INSPECTION NOTICE

PROTECTA REBEL SRL

March 13, 2015

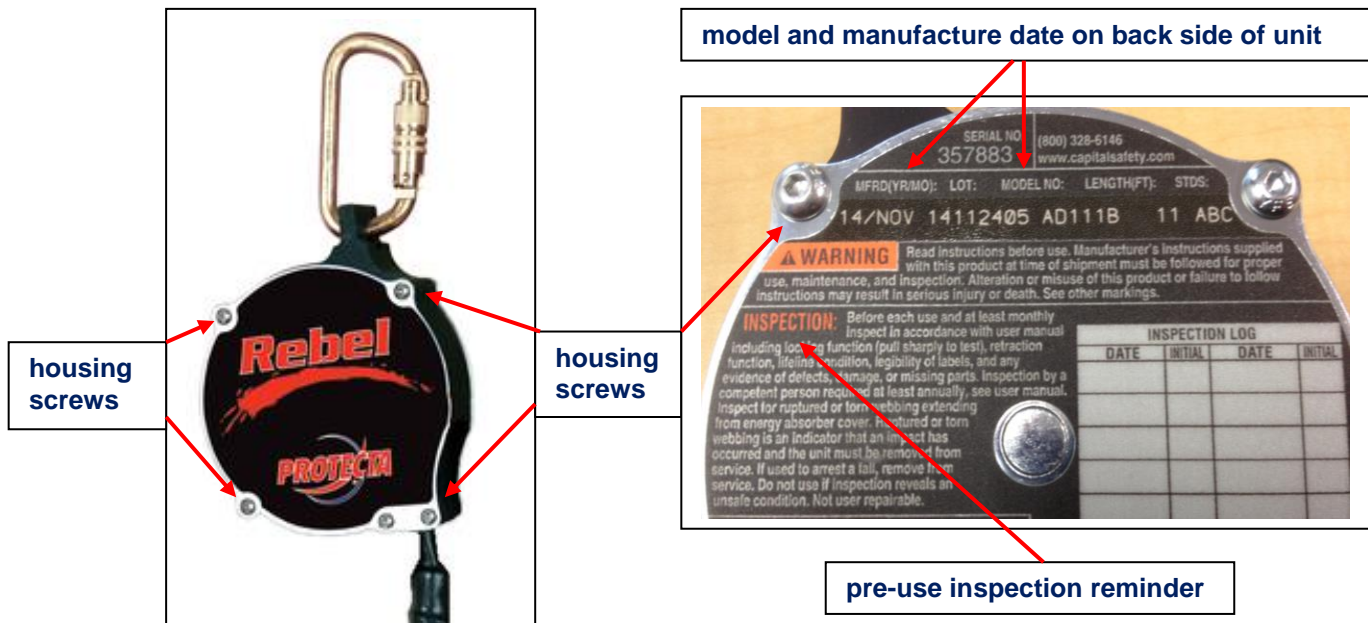
Capital Safety has learned of broken screw heads found in a limited number of Protecta brand Rebel Self-Retracting Lifelines (SRLs). The units affected by this notice are the black, extruded aluminum housing versions of the Rebel, manufactured between 1 April 2014 and 30 November 2014. (See photograph below.) The affected models are:

Although these units passed final assembly inspection by Capital Safety, reports indicate that the heads of some housing screws have been found broken off by end-users. These units have a total of ten externally visible screws that attach the two exterior housing plates to the main housing (five screws on each side, front and back).

Only the Protecta Rebel SRL models identified above are affected by this notice, and only those units manufactured between 1 April 2014 and 30 November 2014. Although we are confident this issue is limited to a select manufacturing lot of screws supplied by our vendor, we have taken the precaution of changing the type of screws used in these units to eliminate any potential of the condition reported.

- a) remind your workers to conduct pre-use inspections of their Rebel SRLs (as well as their other fall protection equipment);
 - the Rebel pre-use inspection checklist is
 - i. summarized on the product label under “Inspection” (see photograph on previous page), “check for any evidence of missing parts” and
 - ii. set out in full in the Rebel user manual, including the specific requirement to check that “all screws and rivets are present.”
 - missing or broken housing screw heads will be readily visible;
- b) if any housing screw heads are missing or broken, take the unit out of service;
- c) if no housing screw heads are missing or broken, the units are safe to remain in service.

What to do if any Rebel SRL manufactured between 1 April 2014 and 30 November 2014 is found with a broken or missing housing screw head: The SRL should be removed from service and returned via distribution to Capital Safety, or users can call our Customer Service department directly at 1-800-328-6146 to arrange to return their unit.
